December 23, 2020

**RE: 5 and 21 Toelles Road and Wharton Brook – Pfizer, Inc.  
Quinnipiac River Backwater Conditions  
Wallingford, Connecticut  
MMI #141.11585.00064.0020**

**FLOOD PROFILES**  
**WHARTON BROOK**

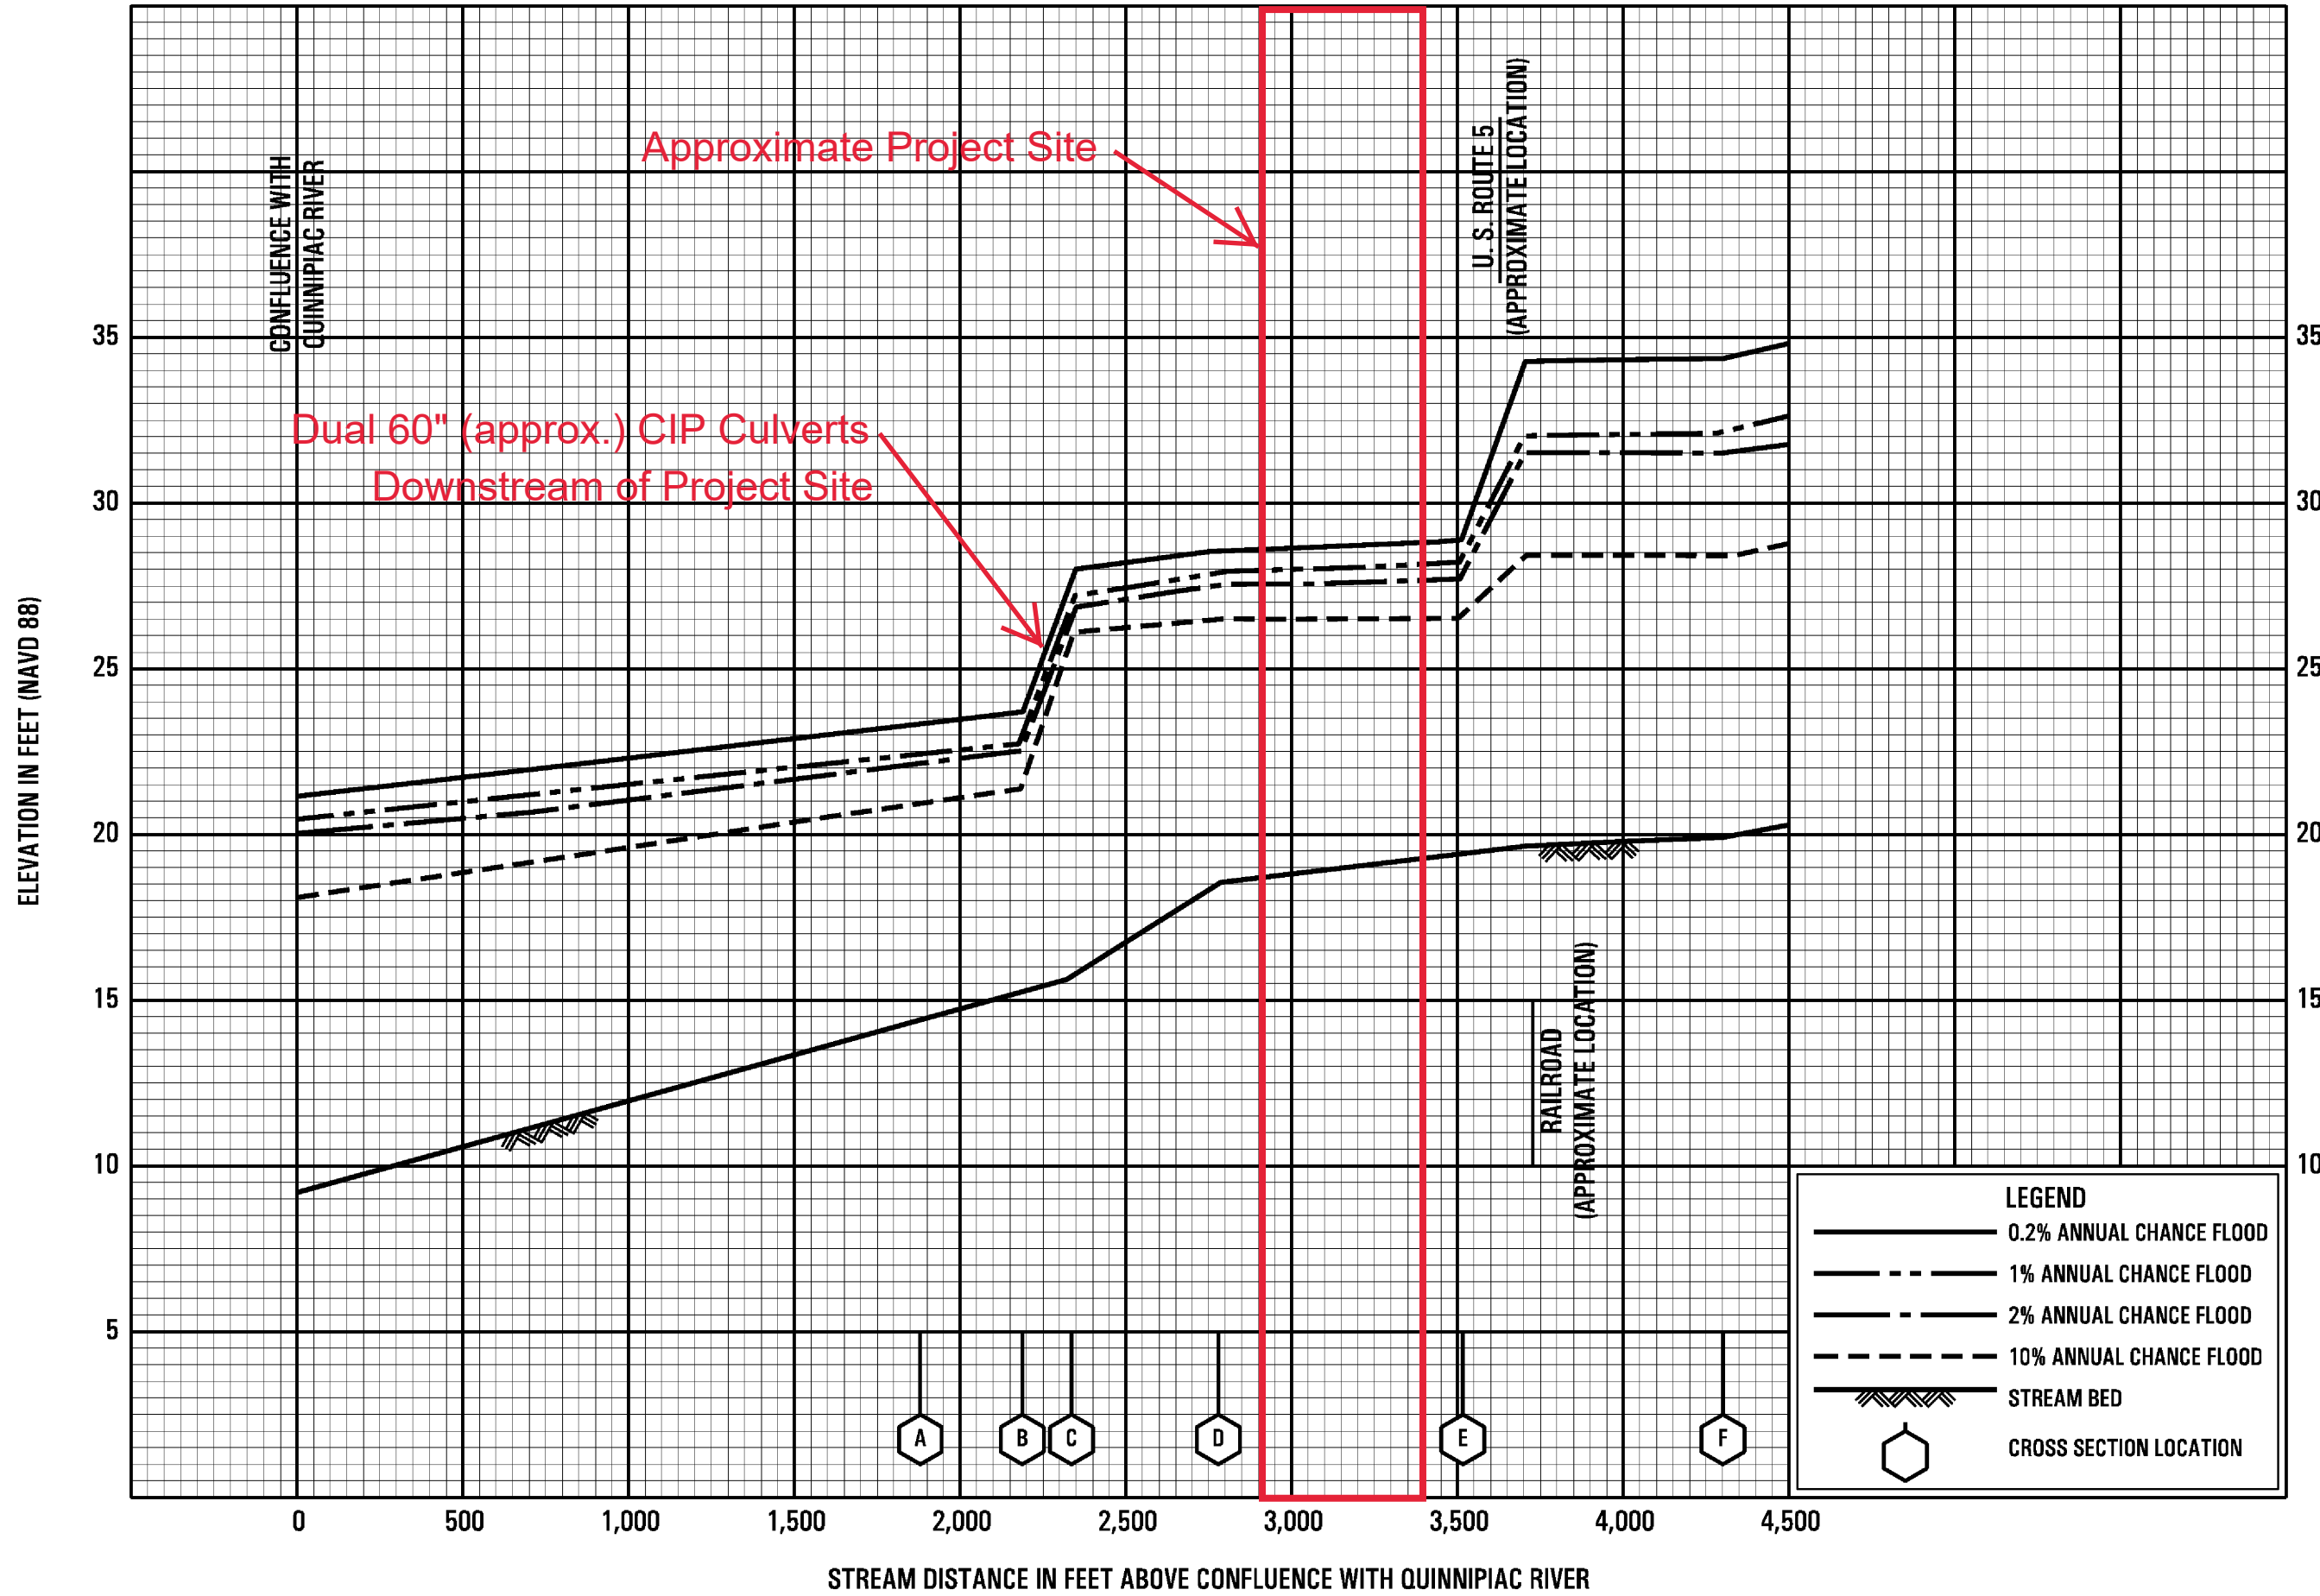
We also assessed the effective Flood Insurance Study (FIS) prepared by the Federal Emergency Management Agency (FEMA) for New Haven County (FIS No. 09009CV010D, Effective May 16, 2017). The relevant page from that study is appended to this letter. We note that the project site falls between FEMA lettered sections "D" and "E." The excerpted profile depicts the flood elevations along Wharton Brook beginning at the confluence with the Quinnipiac River and extending through the project site. From this profile, we note that the flood elevations at the site are hydraulically controlled by a constriction located approximately 1,000 feet downstream of the site. Based on field assessments, we have identified this constriction as dual 60-inch cast-in-place culverts (approximate size) associated with an existing gravel pit access road.

According to the FEMA profile, the 100-year flood elevation in Wharton Brook downstream of the twin culverts is approximately 22.6 feet NAVD, which is lower than the lowest grade on the project site and would not impact the site even if the culverts were not present. However, the undersized culverts cause a substantial (4.6-foot) increase in the 100-year flood and act as the hydraulic control for the project site. The same is true for the other floods assessed by FEMA.

In short, we do not believe that flooding conditions within the Quinnipiac River will have any hydraulic impact on Wharton Brook as it relates to the proposed project.
